Access Compliance Report Public Rights-of-Way (Curb Ramps)

Intersection ID: 10040584 Main Street: W_ARROWOOD_RD Cross Street: N/A Location: NW Initial Pass/Fail: Fail **Overall Compliance: No Severity Score:** ADA ID: 2B93490B25F8 Ramp Type: Perp 37.5

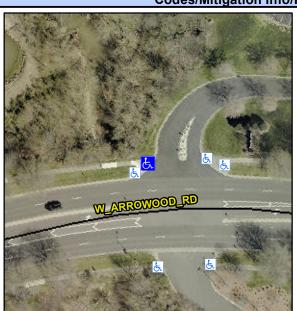
Field Measurements/Component Compliance								
Comp	liance Description	Data	Comp	liance	Description	Data		
N/A	Ramp Length (in)	79.0	No	Ramp	Slope (%)	9.0		
Yes	Ramp Width (in)	48.0	No	Ramp	XSlope (%)	8.3		
N/A	Flare Type LT	N/A	N/A	Flare	Type RT	N/A		
N/A	Flare Slope LT (%)	N/A	N/A	Flare	Slope RT (%)	N/A		
N/A	Flare Traversable LT?	N/A	N/A	Flare	Traversable RT?	N/A		
N/A	Landing Length (in)	N/A	N/A	DWS	Provided?	N/A		
N/A	Landing Width (in)	N/A	N/A	DWS	Contrast?	N/A		
N/A	Landing Slope (%)	N/A	N/A	DWS	Length (in)	N/A		
N/A	Landing X Slope (%)	N/A	N/A	DWS	Full Width?	N/A		
N/A	Landing Curb? (Y/N)	N/A	N/A	DWS	Offset (in)	N/A		
N/A	Shared Landing?	N/A						
N/A	Gutter Ponding?	N/A	N/A	Gutte	r Slope (%)	N/A		
N/A	Gutter Lip Ht (in)	N/A	N/A	Gutte	r X Slope (%)	N/A		
N/A	Painted X Walk1?	No	N/A	Paint	ed X Walk2?	N/A		
	X Walk 1 Direction	To E		X Wa	lk 2 Direction	N/A		
N/A	X Walk 1 Width (in)	N/A	N/A	X Wa	lk 2 Width (in)	N/A

X Walk 1 Slope (%)	3.2		X Wa	lk 2 Slope (%)	N/A		
	X Walk 1 X Slope (%)	6.3		X Wa	lk 2 X Slope (%)	N/A		
N/A	Ramp inside XWalk1?	N/A	N/A	Ramp	inside XWalk2?	N/A		
	Road Slope (%)	N/A	N/A	Clear	Space?	N/A		
	Road X Slope (%)	N/A	N/A	Clear	Space to XWalk (in)	N/A		
N/A	Any Obstructions?	N/A	N/A	Storm	Grate/Utility Hazard?	N/A		
	Obstruction Type			Storm	Grate/Utility Type			
		N/A				N/A		
			Yes	Surfa	ce Condition? (G/P)	Good

Possible Solutions:	Cor
Remove & Replace Entire Ramp.	N/A
	Yes
	N/A
	N/A
	N/A
	N/A
Surveyor Notes:	N/A
N/A	N/A
	N/A
	N/A
	N/A
PROW/ADA:	N/A
R304.2.2, R304.5.3	N/A
	N/A
	N/A
	N/A
